Addendum Number: 02**Addendum Issue Date:** January 14, 2026**Owner:** Robinson-Palestine Water Commission**Project Name:** Water Treatment Plant and Campus**Project Number:** 0210007.00**Containing:** # Pages; # Drawings; # Specifications

12. SHEET C1 & C2 – PROVIDED as a standalone attachment with the addendum. These sheets pertain to Rte. 1 and Rte. 33 watermain crossing. These sheets were included in the original specifications, as a permit attachment for the aforementioned crossings. The attached sheets with the addendum are a higher resolution version of the of the same sheets that were provided with the original specifications.

PROJECT:
**Robinson-Palestine Water
Commission**

Water Treatment Plant and Campus

GRADING PLAN

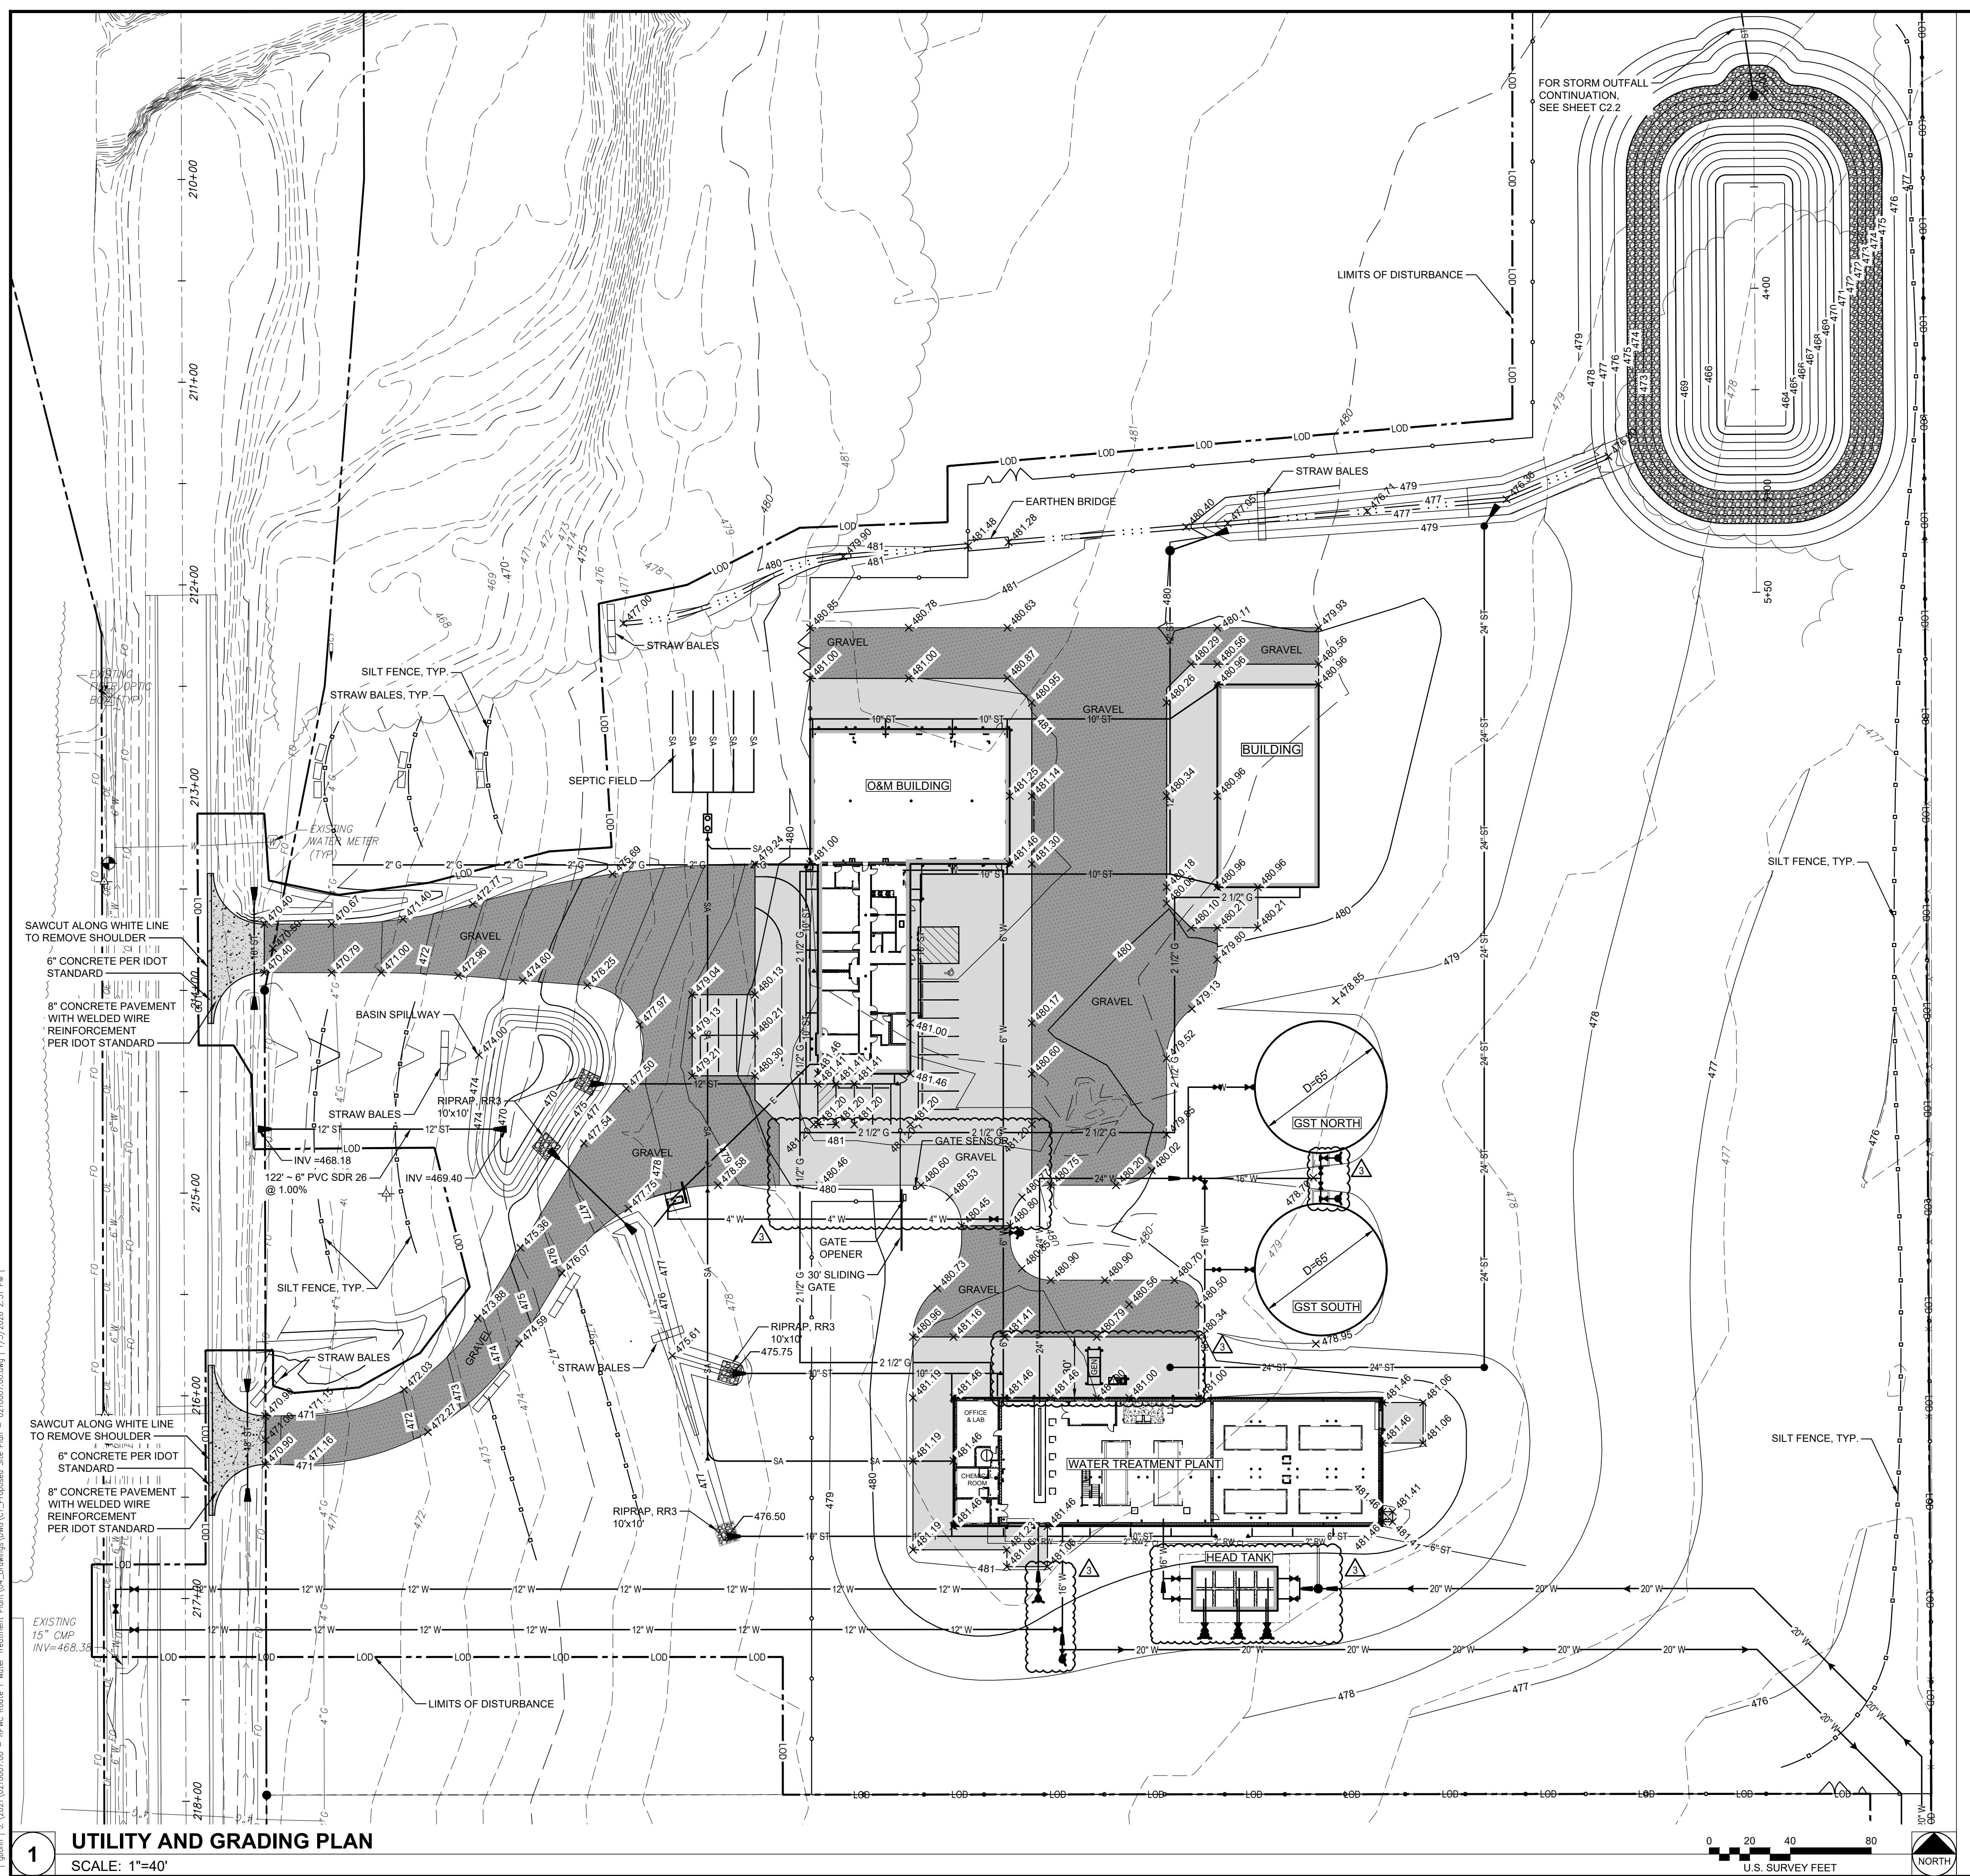
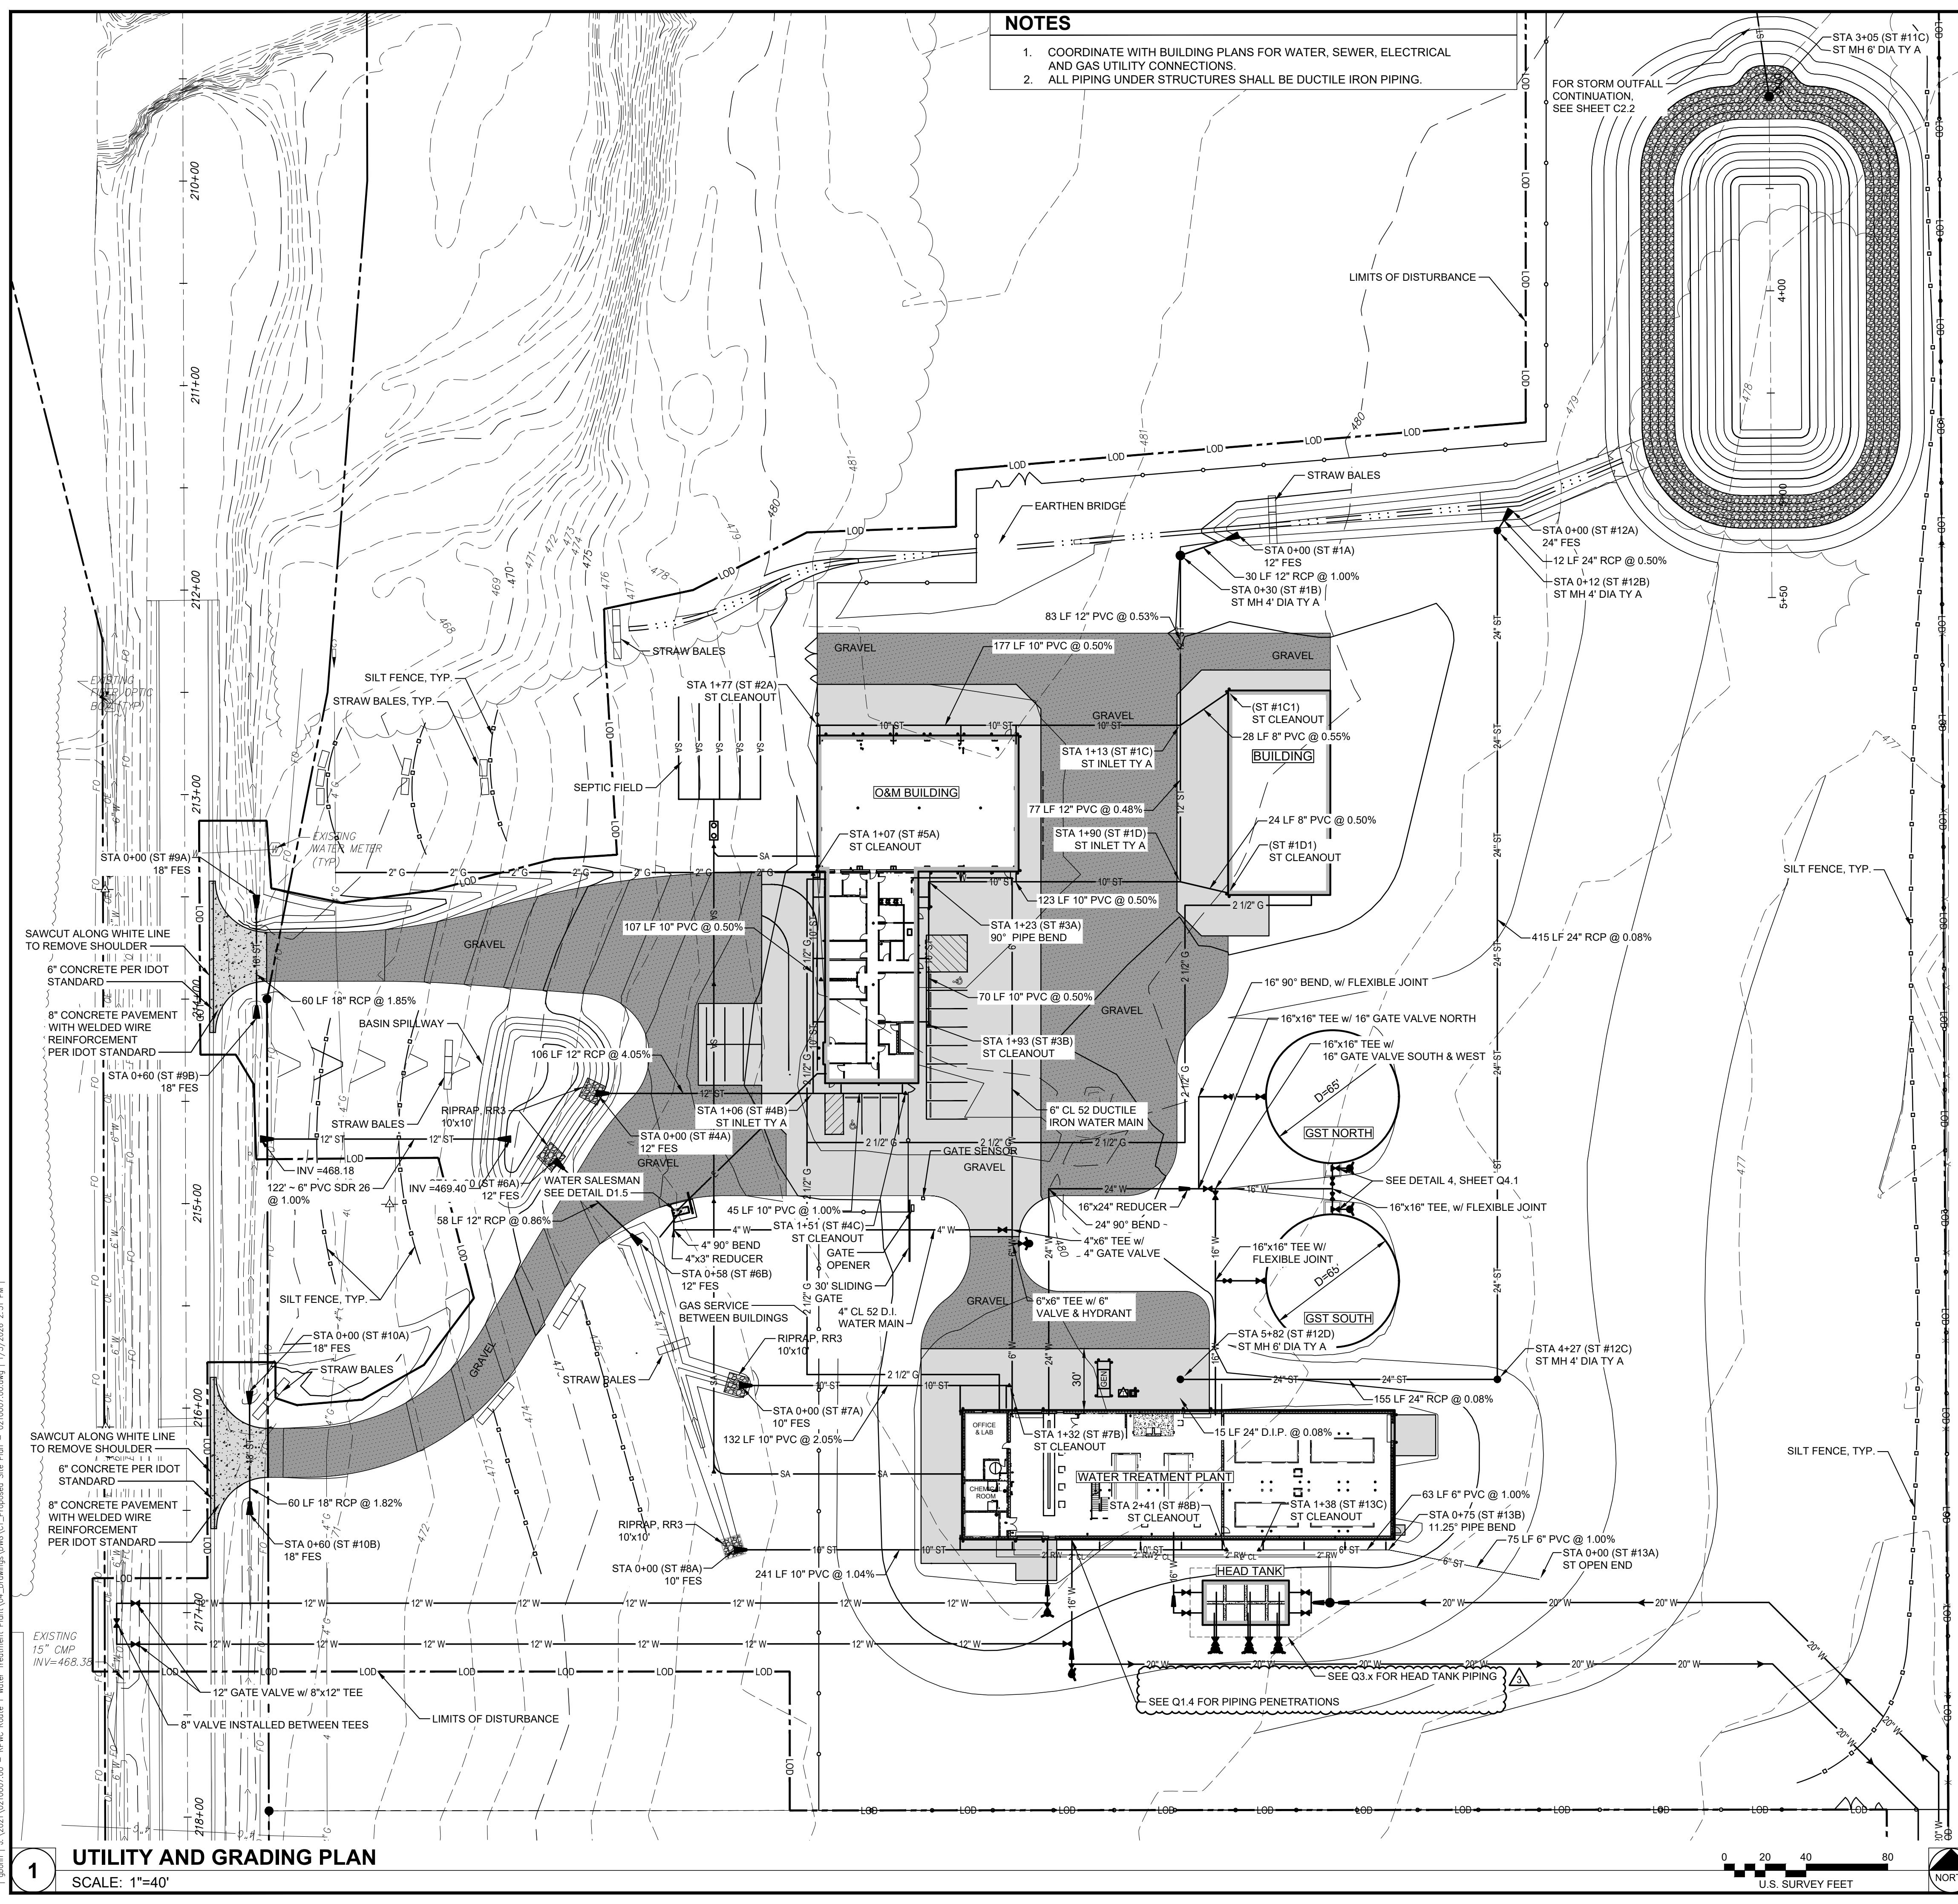
1. Replace Sheet C1.1 and Sheet C2.1 with the attached sheets. Revisions are clouded in the attached drawings.
2. SHEET 01A2.1 – ~~DELETED~~ ridge vent notation at PEMB. REVISED gutter material of PEMB to metal, in lieu of aluminum.
3. SHEET 01A3.1 –
 - a. ~~DELETED~~ ridge vent notation at PEMB. REVISED gutter and downspout material of PEMB to metal, in lieu of aluminum.
 - b. ADD overall dimensions to signage elevations.
